PROPOSED AMENDMENT 182

PROPOSED DEFUELED TECHNICAL SPECIFICATIONS

RANCHO SECO UNIT 1
TECHNICAL SPECIFICATIONS

FIGURE D5.1-3
SITE BOUNDARY FOR GASEOUS EFFLUENT

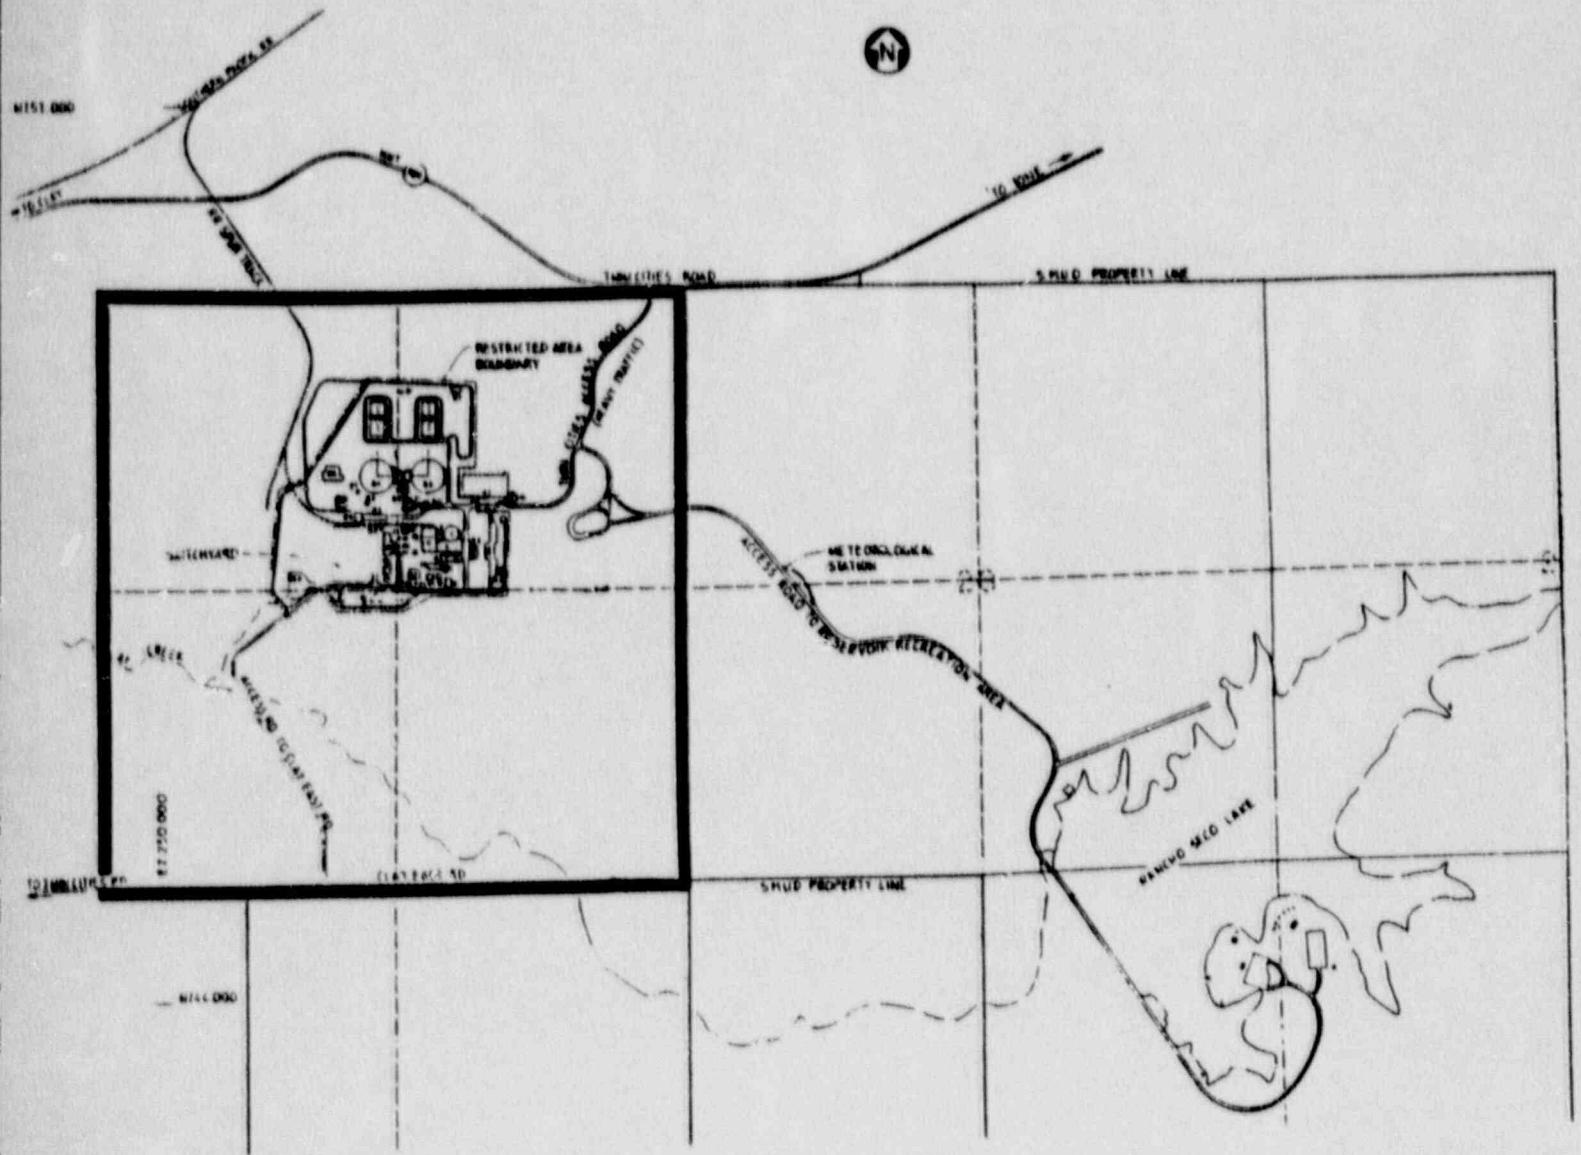
Specification 3.18.1 was modified in the ODCM to use the Site Boundary for Gaseous Effluents, Defueled Technical Specification Figure D5.4, in lieu of the Exclusion Area currently used for "Dose Rate" calculations. This change is consistent with current "Dose" calculations and NUREG-0133, Preparation Of Radiological Effluent Technical Specifications For Nuclear Power Plants.

FIGURE D5.1-4
SITE BOUNDARY FOR LIQUID EFFLUENT

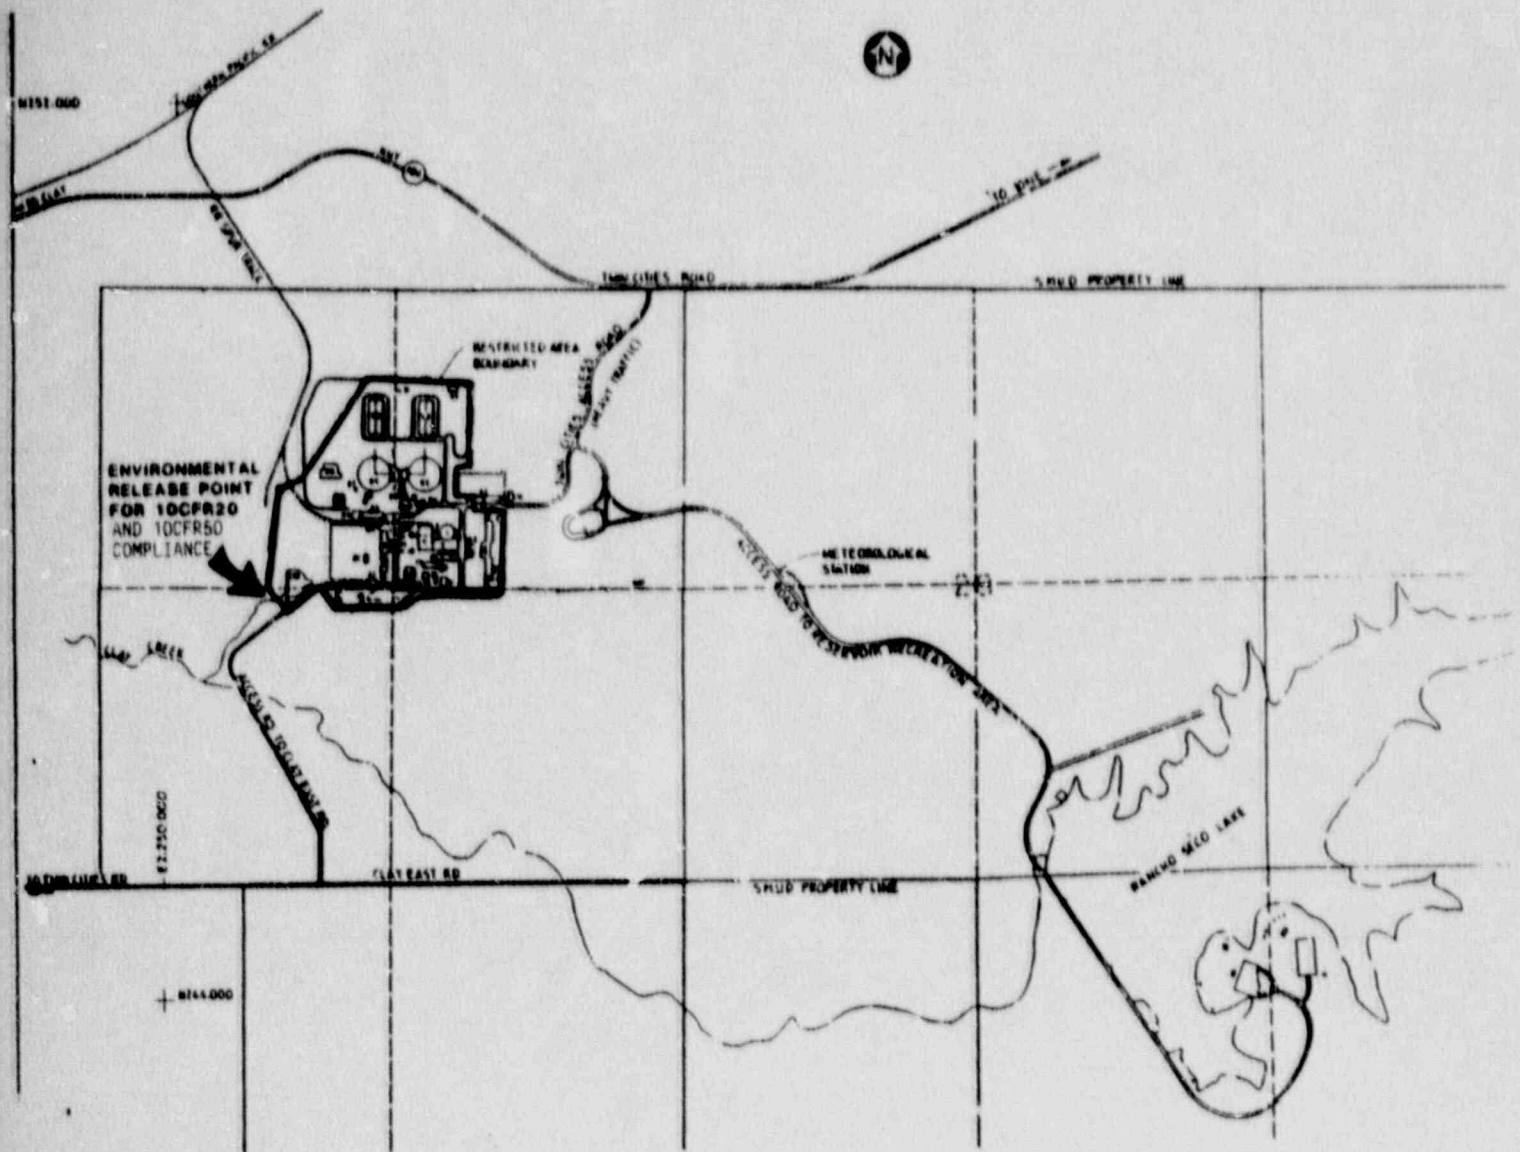
- 5.1 The Site as described in the Appendix A Technical Specifications has been modified to show the Site Boundary For Liquid Effluents for both 10 CFR 50, Appendix I, and 10 CFR 20 compliance on one drawing for clarity. The Site Figures are included in Defueled Technical Specifications Section D5.0. Non applicable details have been removed from the Figures for clarity.
- 5.2 This section which describes the Reactor Building has not been included since it is not applicable in the Defueled Mode.
- 5.3 This section which describes the Reactor has not been included since it is not applicable in the Defueled Mode.
- 5.4 The descriptions for spent fuel storage in the Spent Fuel Storage Building have been included as DTS D5.2. The remainder of this Specification which addresses new fuel storage is not applicable in the Defueled Mode and is not included.
